**Pier 26 Upland Park Construction – Electrical Construction
Project/Contract #C4891-C
Addendum # 4
December 3, 2018**

(A) "1. C4891 –A-E Pier 26 Upland Park Construction" is amended to include the following drawing modifications:

(B) "4. C4981-C Electrical Construction – Specifications" is amended to include the following specification modifications:

GRADING PLAN - PIER D

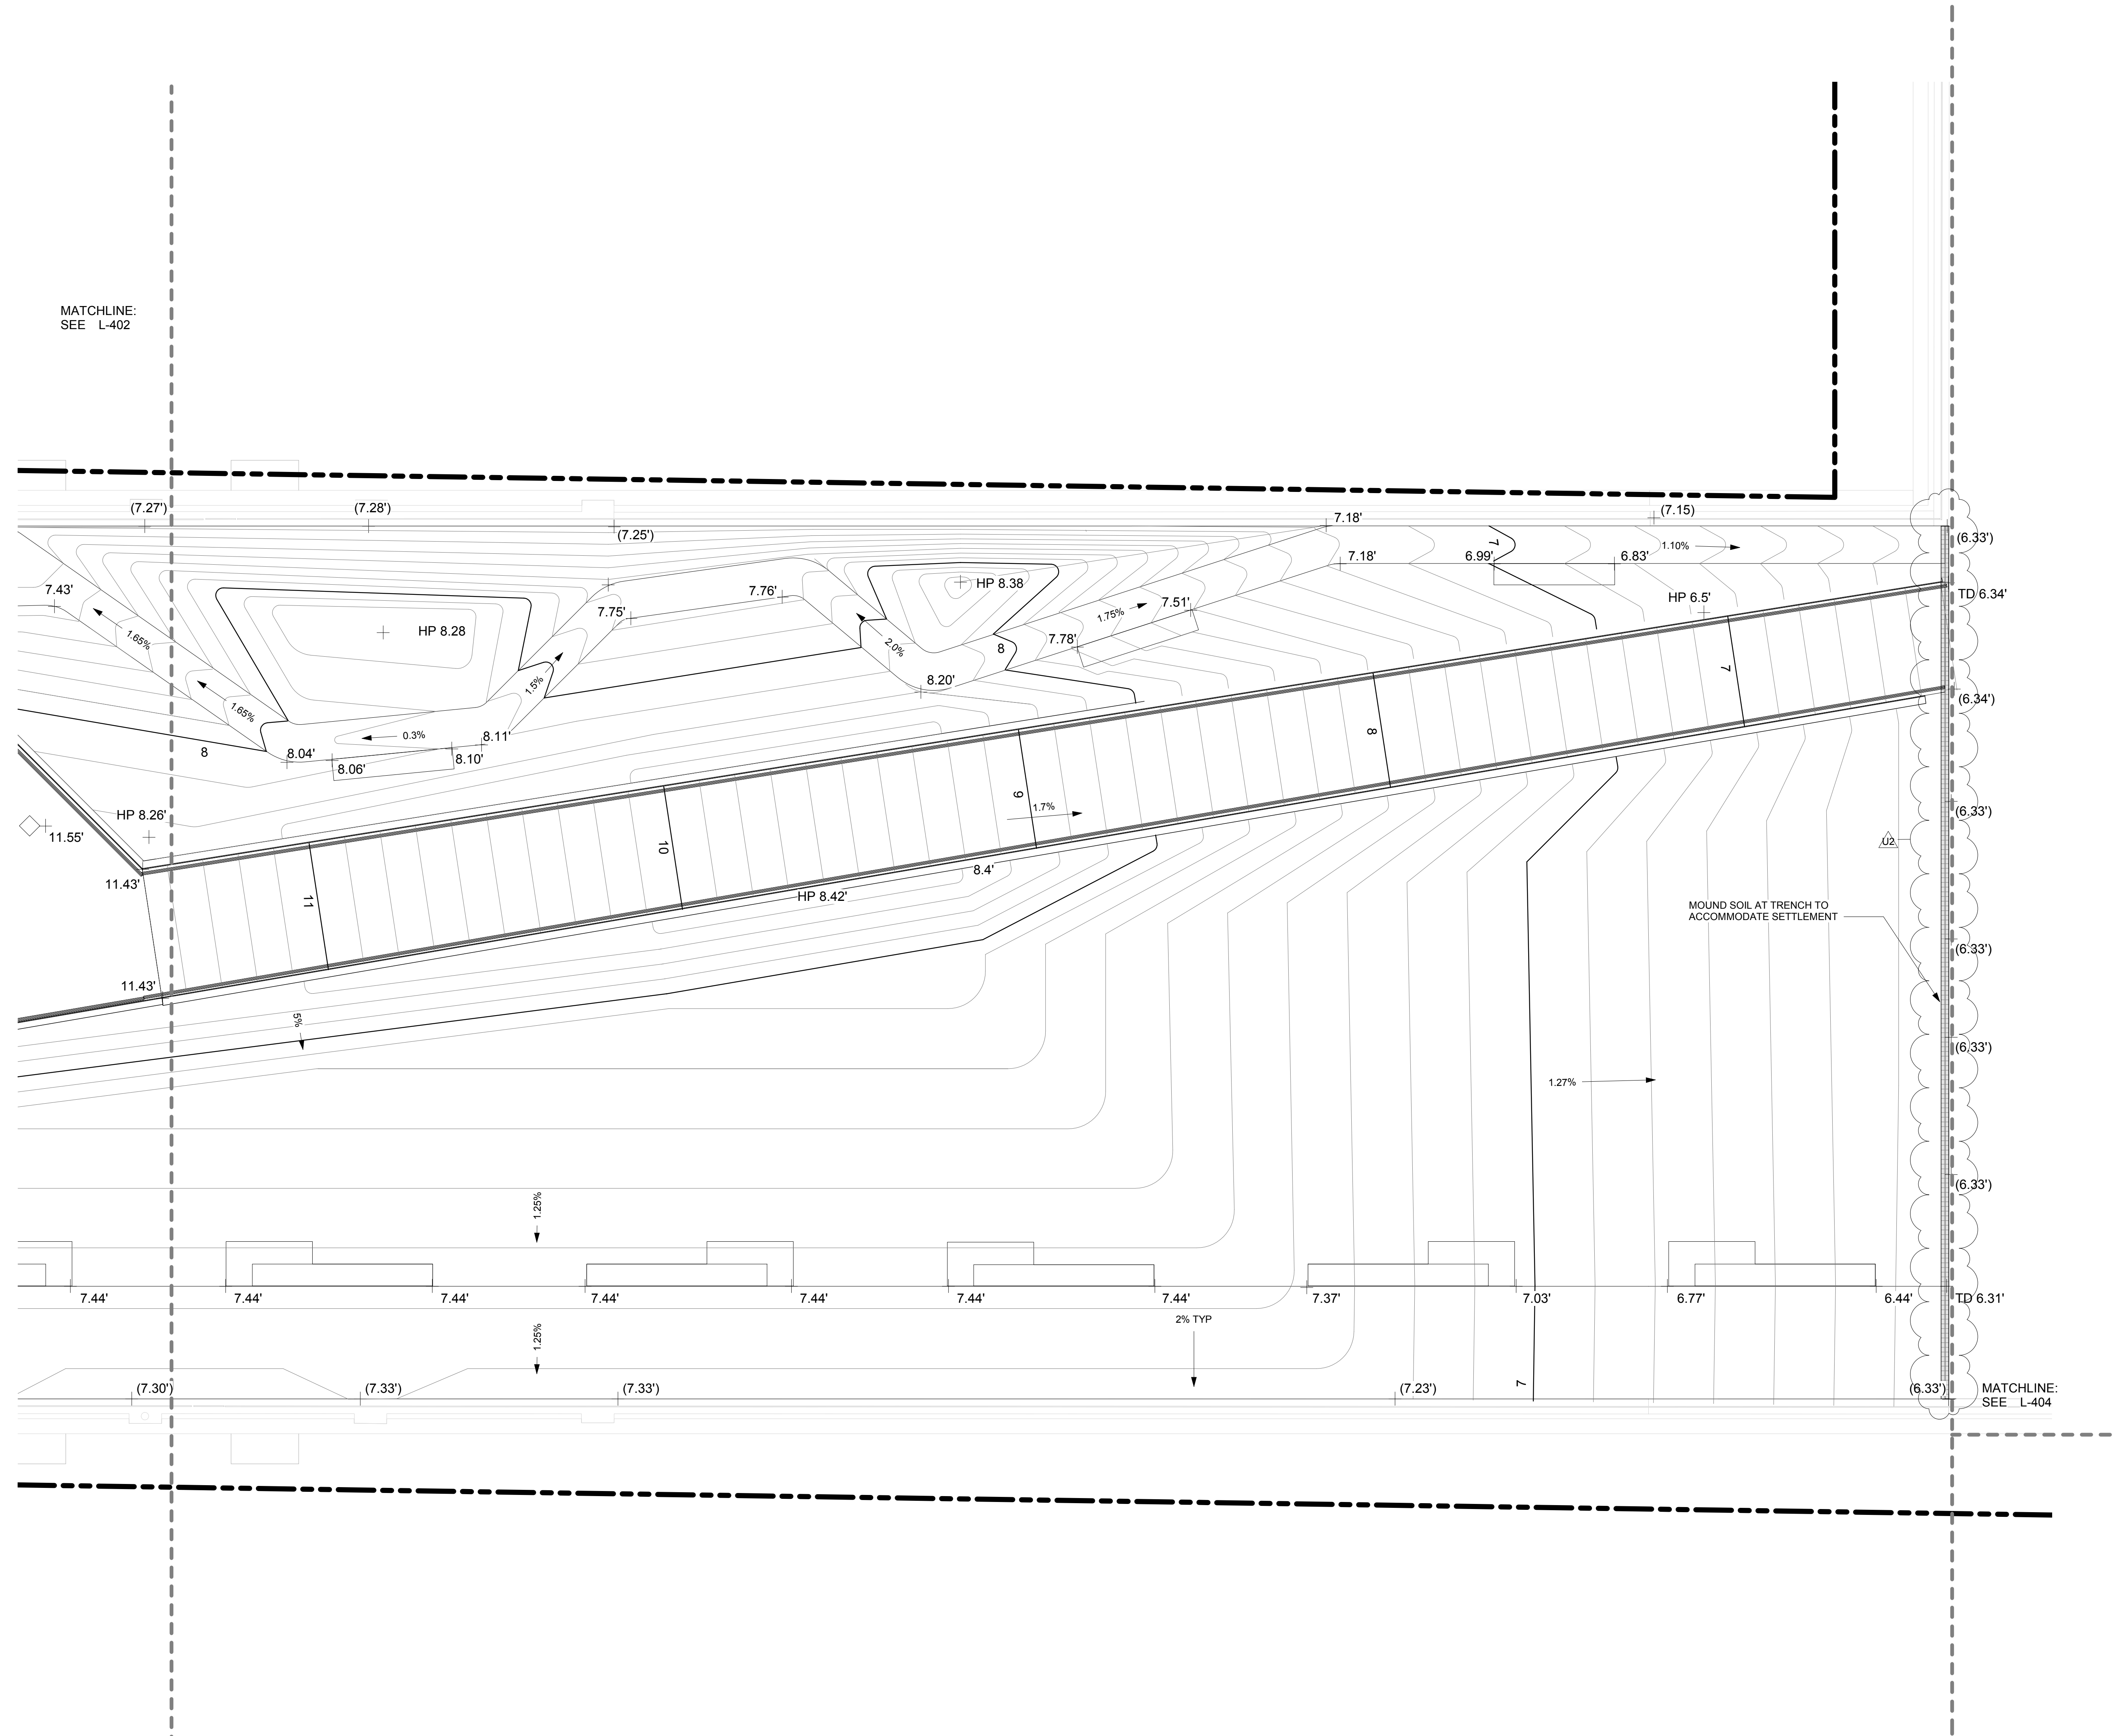
L-402 - GRADING PLAN - PIER C	Symbol for slot drain and trench drain has increased visibility.
L-403 - GRADING PLAN - PIER D	Symbol for slot drain and trench drain has increased visibility.
L-404 - GRADING PLAN - NORTH UPLAND	Symbol for slot drain and trench drain has increased visibility.
S-301 - FRAMING PLAN - PIER B	Walkway south of seating terrace no longer called out as 8" concrete seating step.
S-302 - FRAMING PLAN - PIER C	The thickness of the concrete is correctly labeled to show the 8" depth only at the 15' wide southern, as in the materials plans.
E-301 - ELECTRICAL PLAN - PIER B	Location of Q-vault shown.
E-302-ELECTRICAL PLAN - PIER C	Electrical clarification to sport pole.
E-308 - WOOD AND STEEL SHED ELECTRICAL DETAILS.pdf	New sheet showing clarifications of electrical work at the sheds.
P-303 - SANITARY PIPING PLAN - PIER D	Cross section of piping added.
P-312 - SANITARY PIPING PLAN - PIER C	Clarification to boat service utilities.
